**PLANNING & ZONING COMMISSION
Special Meeting
Wednesday, February 1, 2017
6:30 p.m.**

TO: Planning & Zoning Commission
FROM: Heather Valone, Village Planner
THRU: Jeffery Stein, Deputy Village Administrator
SUBJECT: Case 14-12 Donegal Excavating PUD
DATE: January 4, 2017

Case No. 14-12
Project Name Donegal Excavating

Re: Donegal Excavating
Case #2014-12
Plan Review #1

SITE DEVELOPMENT PLAN
ROUTE 83 PROPERTIES

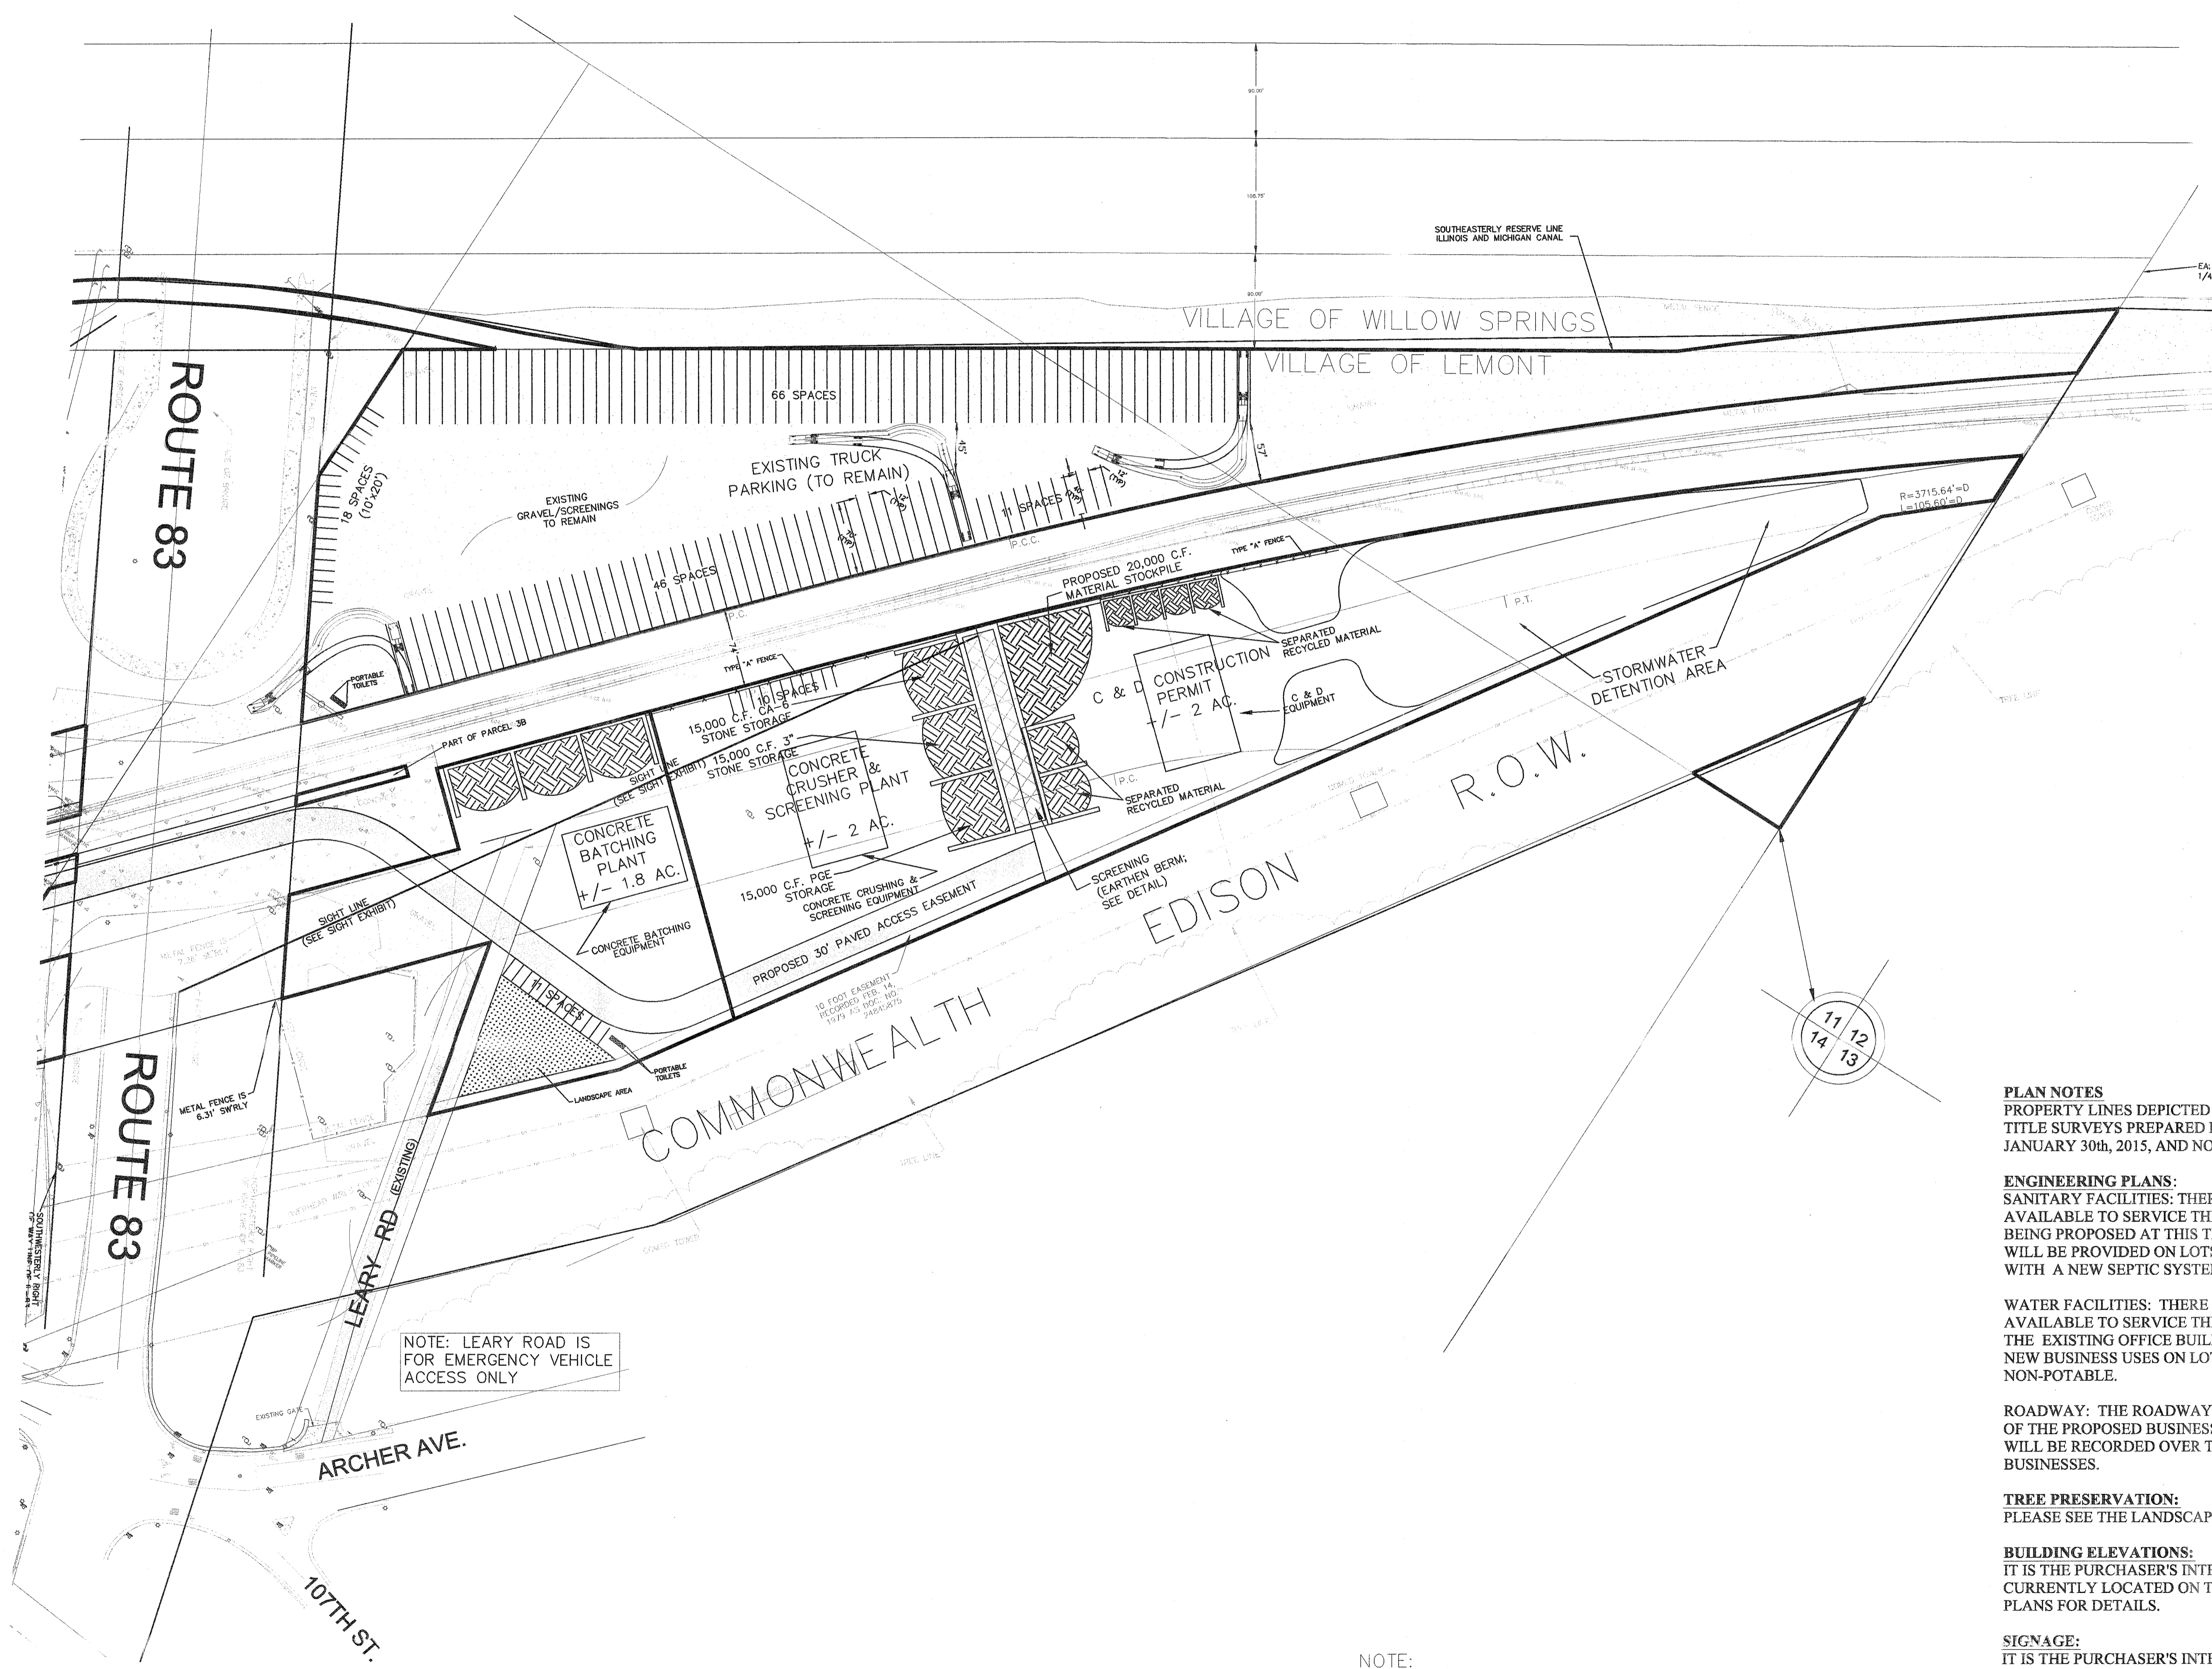
Maximum lot coverage 70%	9.7%	The plans provide a table of the proposed impervious surfaces indicating a total impervious lot coverage of 9.7%; however, these calculations do not match the impervious areas on the plan. The plan shows almost 100% lot coverage of the majority of the parcels that make up the subject area. Staff is recommending that the applicant

The plans also propose equipment will be stored in the front yard of the existing truck washing and repair building. That equipment is believed to be cranes, but will need to be clarified by the applicant. The storage of this equipment should be moved northwest behind the building on lot 1. Storage of materials and equipment/trucks should not be placed in the front yard of the subject property.

Lot 6 is shown as truck parking. The farthest east portion of the site is not indicated for truck parking just as a gravel area. Staff is recommending that if the applicant is not utilizing the area it should be converted into grass space to prevent trucks parking on the area. The preliminary plat of survey also indicates a 10 ft. utility easement around the lot. As such the truck parking spaces should not be shown in these easements, staff is recommending that the applicant revise the engineering plans accordingly.

1. Revise the engineering plans and architectural plans to observe a 15 ft. front yard setback for the proposed office and truck maintenance building on Lot 2.
2. Update the impervious lot coverage table to indicate the actual proposed lot coverage. The PUD site plan must be revised to demonstrate compliance with UDO lot coverage maximums for the M-3 zoning district.

17. Revise the site plans to remove the storage of materials and equipment/trucks from the front yard of Lot 1.
18. Revise the landscaping and site plans to show the non-truck parking area (far east portion) of Lot 6 as a landscaped area.

19. Update the engineering plans to remove truck parking from the 10 ft. utility easement as indicated on the preliminary plat.
20. Revised architectural plans to show no EFIS material on the proposed office and truck maintenance building.
